P&A Procedure

BP America – FLORANCE GC E 9

Re: Permanent Abandonment  
Well: Florance GC E 9

CONDITIONS OF APPROVAL

Proposed Schematic

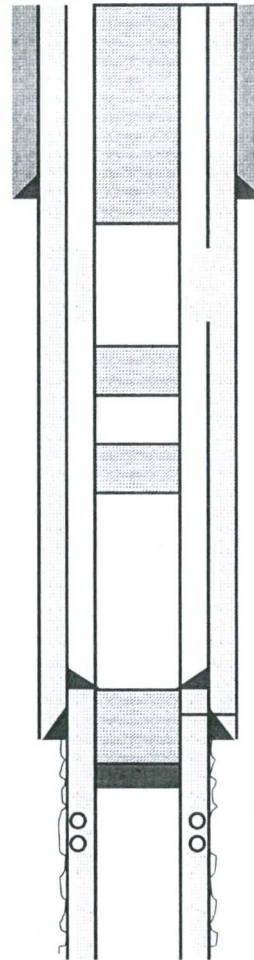
- Notify NMOCD 24hrs prior to beginning operations.
- Plugs from Picture Cliff formation up will need perforations to see if a rate can be established, even if CBL shows coverage due to unknown cement behind 7" casing. Please see the note on the 1982 wellbore schematic from the USGS.

1. Plugging operations authorized are subject to the attached "General Requirements for Permanent Abandonment of Wells on Federal and Indian Lease."
2. Farmington Office is to be notified at least 24 hours before the plugging operations commence (505) 564-7750.
3. The following modifications to your plugging program are to be made:
  - a) Add a cement plug (3194 – 3094) ft. to cover the Chacra top. BLM picks top of Chacra at 3144 ft.
  - b) Set Plug 2 (2486 – 2094) ft. to cover the Pictured Cliffs and Fruitland tops. BLM picks top of Pictured Cliffs at 2436 ft. BLM picks top of Fruitland at 2144 ft.
  - c) Set Plug 3 (1446 – 1154) ft. to cover the Kirtland and Ojo Alamo tops. BLM picks top of Kirtland at 1396 ft. BLM picks top of Ojo Alamo at 1204 ft.

Operator will run a CBL to verify cement top. Submit the electronic copy of the log for verification to the following addresses: [jwsavage@blm.gov](mailto:jwsavage@blm.gov) [Brandon.Powell@state.nm.us](mailto:Brandon.Powell@state.nm.us)
